Public Comment No. 1653-NFPA 70-2024 [Global Input]

This Global Public Comment is for CMP-13 to review the use of the terms “overcurrent”, “overcurrent protective devices” and “overcurrent protection”.

Figure 7 - Set point temperature per ASTM E119 vs. actual furnace temperature

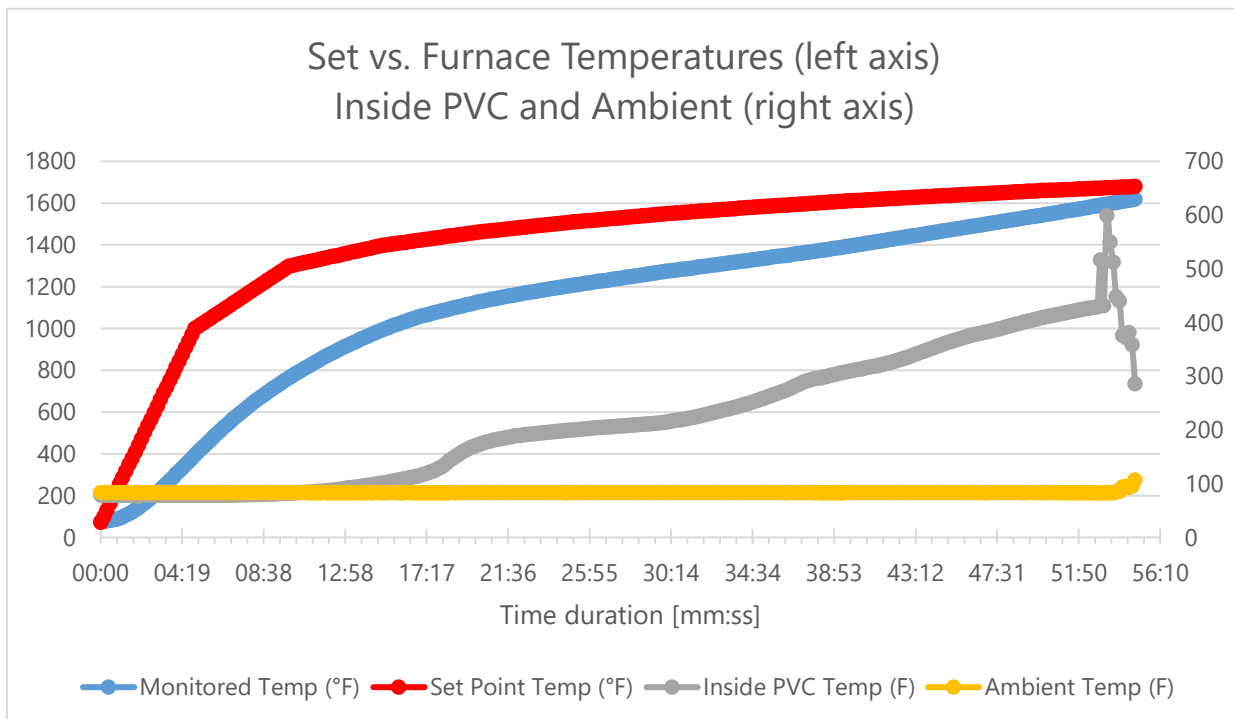
Of note is the fact that the tube furnace power output was not powerful enough to follow the ASTM E119 time-temperature curve given the concrete volume needed heating. Due to this, the external temperature exposure is less severe than what it would have been in a full-scale furnace. This lagging effect can be seen in Figure 7. Circuit integrity should be compromised more quickly on a furnace that is powerful enough to follow the ASTM E119 time-temperature curve.

Figure 8 - Measured external temperature vs. internal temperature and Voltage Chart (Siliceous)

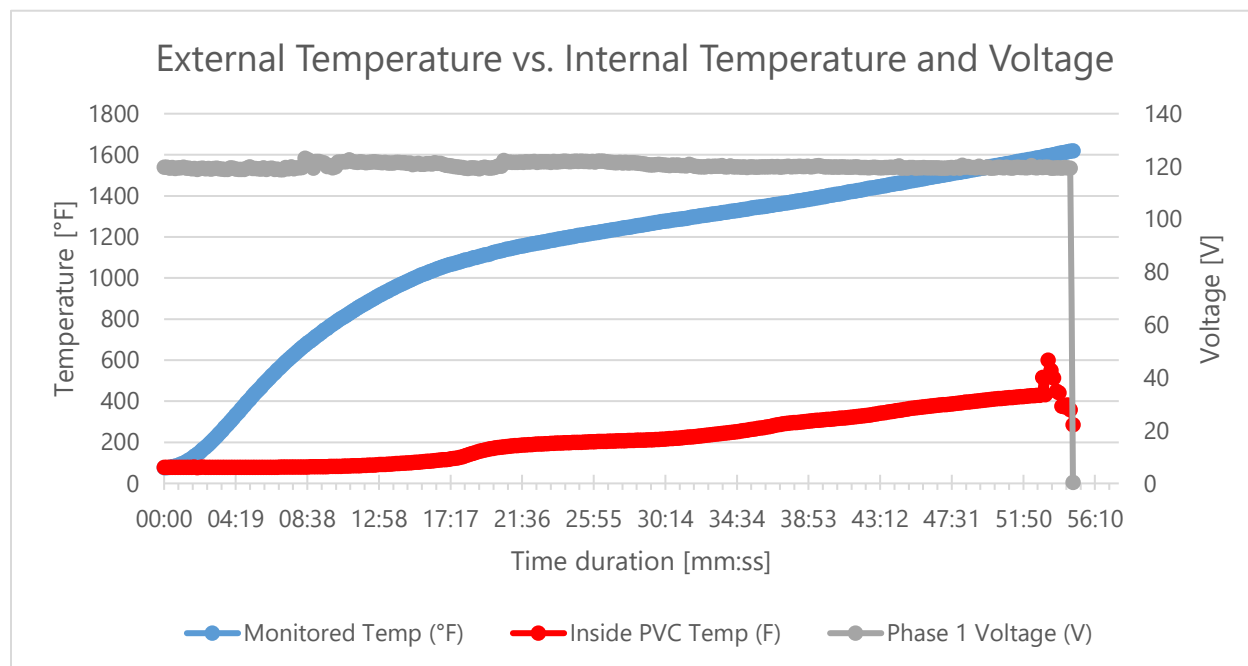
This test was conducted on July 22, 2024. Circuit integrity failed at approximately 54 minutes as seen in Figure 8, when the voltage dropped from ~120V to 0V, and the light went out. Erratic behavior on the temperature measured by the thermocouple probe inside the PVC can be noticed starting at 53 minutes, most likely due to grounding faults induced by the insulation starting to fail and shorting the probe next to the wires.

Figure 11 - Measured external temperature vs. internal temperature and Voltage Chart (Carbonate)

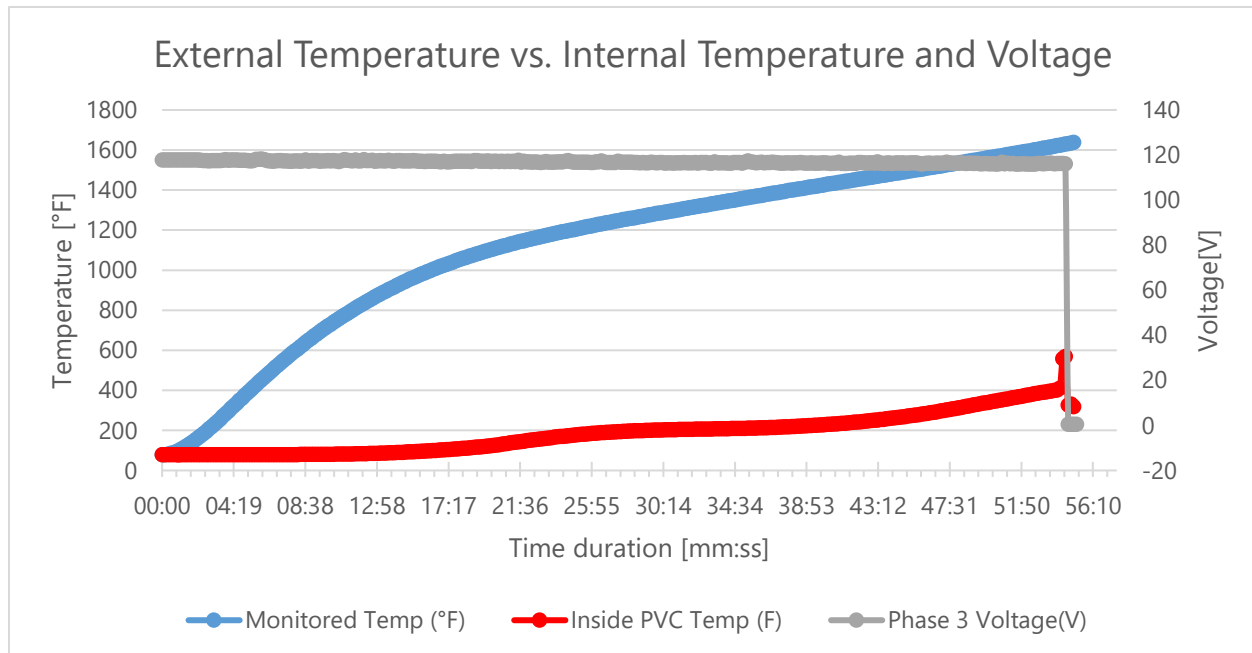
This test was conducted on July 25, 2024. Circuit integrity also failed at approximately 54 minutes as seen in Figure 11.

Figure 14 - Measured external temperature vs. internal temperature and Voltage Chart (Lightweight)

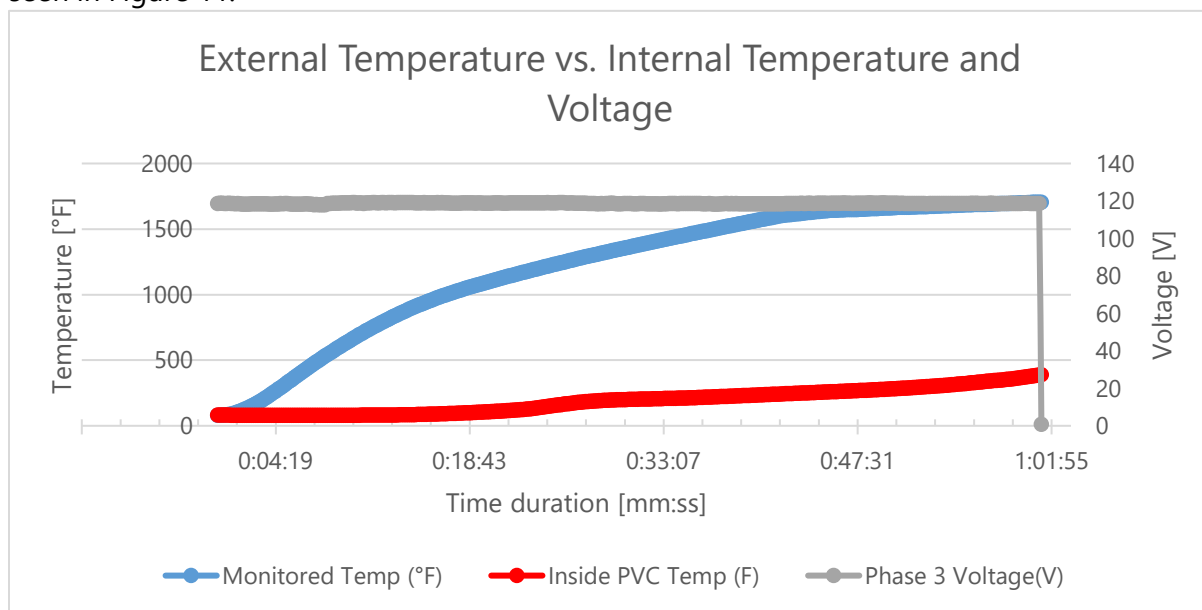
This test was conducted on July 26, 2024. Circuit integrity failed at approximately 61 minutes as seen in Figure 11.

Separately Derived Systems

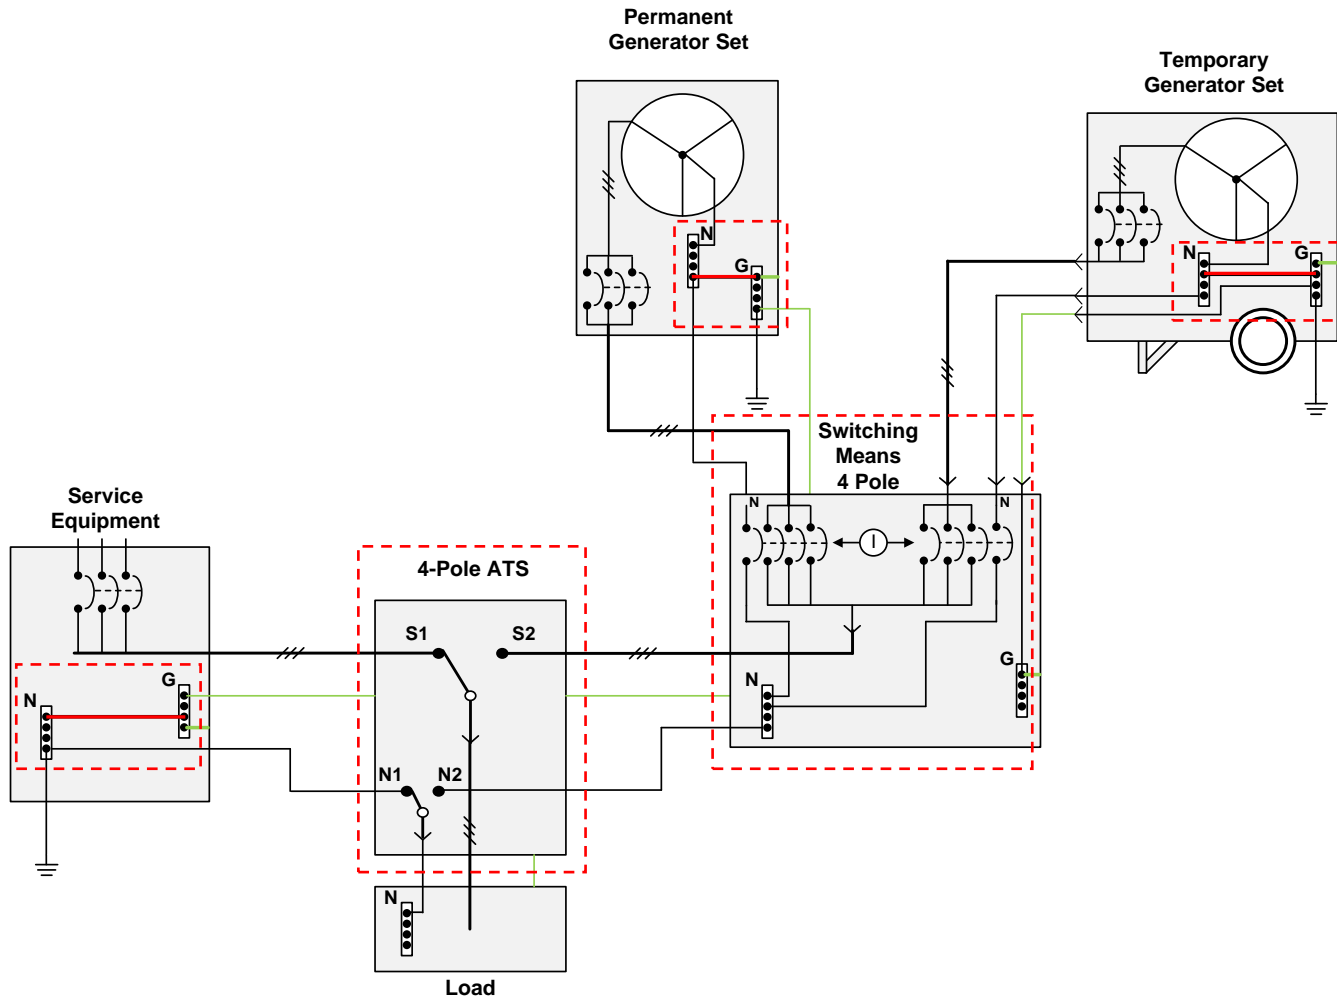
- Neutral to Ground Bonding Jumper at Service Equipment
- Neutral to Ground Bonding Jumper at Permanent Generator
- 4-Pole ATS
- 4-Pole Switching Means
- When Temporary Genset is used, Neutral to Ground Bonding Jumper at Temporary Genset

Separately Derived Systems - Misapplication

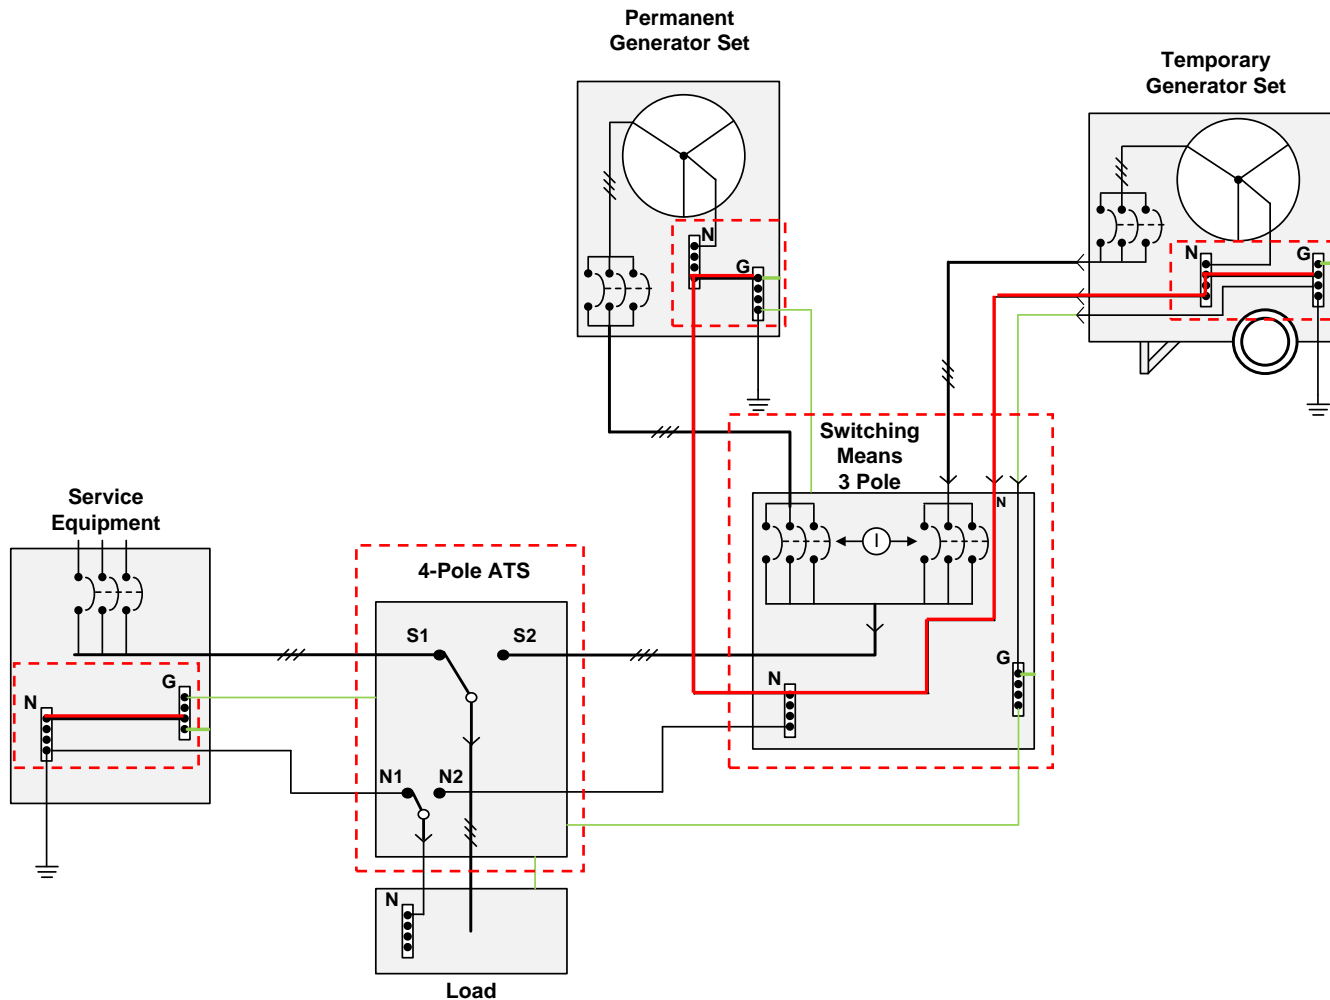
- Neutral to Ground Bonding Jumper at Service Equipment
- Neutral to Ground Bonding Jumper at Permanent Generator
- 4-Pole ATS
- 3-Pole Switching Means
- When Temporary Genset is used, Neutral to Ground Bonding Jumper at Temporary Genset
- Multiple or No Neutral Bonding Jumper on Generators (Multiple Jumpers Shown).

Figure 1

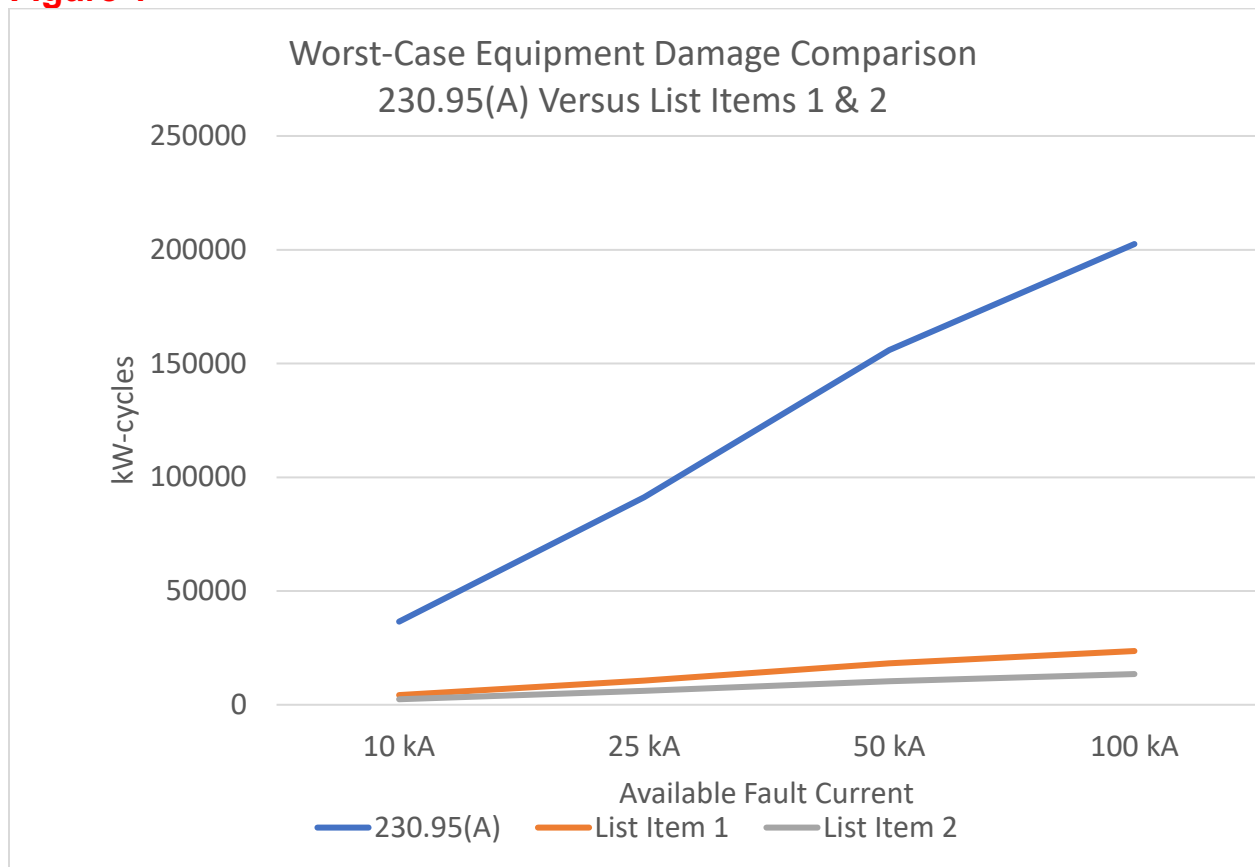
The IEEE 1584-2018 minimum arcing current is 6.09kA. Using the maximum 230.95(A) opening time of 60 cycles, the equipment damage is (6.09 kA X 60 cycles X 100 arcing volts) = 36,540 kW-cycles. See Figure 1.

The IEEE 1584-2018 minimum arcing current is 6.09kA. Assuming an opening time of 4 cycles for 240.87(B)(1), (B)(2), or (B)(4), the equipment damage is (6.09 kA X 4.0 cycles X 100 arcing volts) = 2,436 kW-cycles. Assuming an opening time of 3 cycles for 240.87(B)(5) or (B)(6), the equipment damage is (6.09 kA X 3 cycles X 100 arcing volts) = 1,827 kW-cycles. Worst-case damage for the minimum arcing current with this exception for circuit breakers (2,426 KW-Cycles) is less than 7% of the worst-case damage allowed by 230.95(A) (36,540 kW-cycles). See Figure 1.

Figure 1 shows that equipment damage allowed by this Public Comment is always, from 10,000 amperes available through 100,000 amperes available, just a small fraction of the equipment damage allowed by 230.95(A).
